Upper's Quarry

Plan Scale: 1:3000 (Arch E) Date: October 2021

File Name: Existing Features

Drawing No.: 1 of 6

Key Natural Heritage Features Schematic

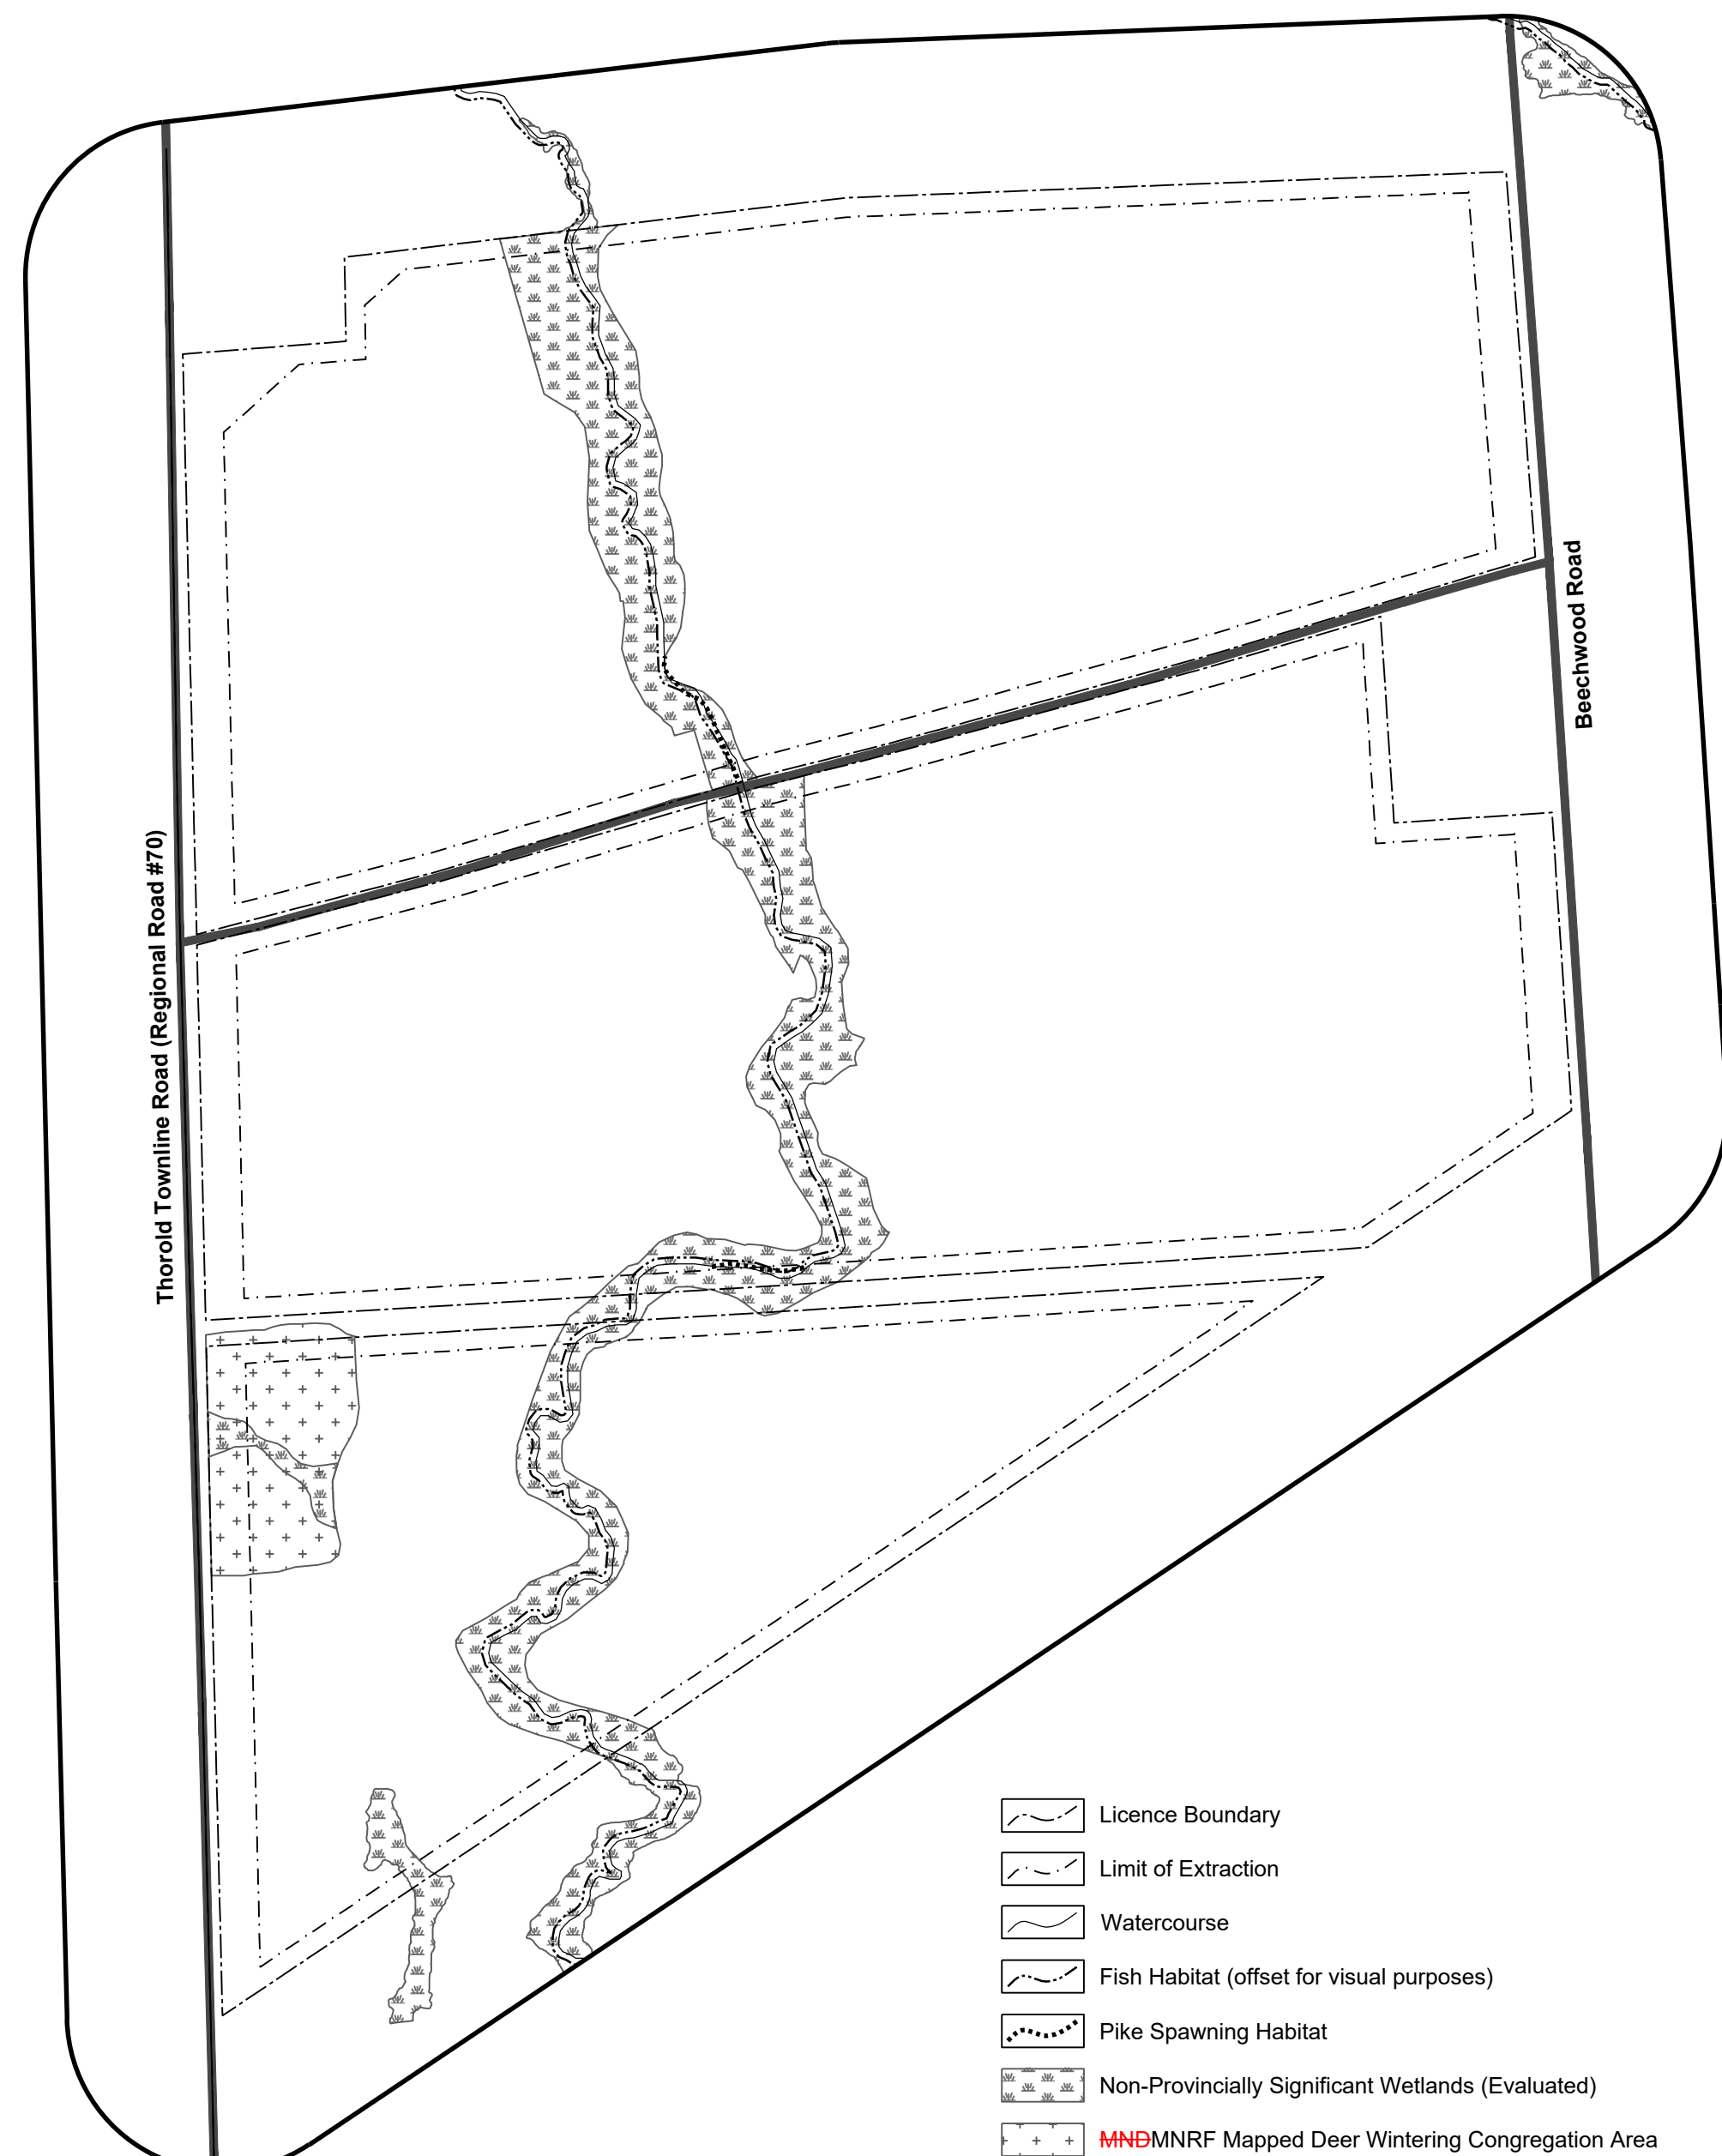
Changed line type

Added additional homes within 300 metres of the licence boundary
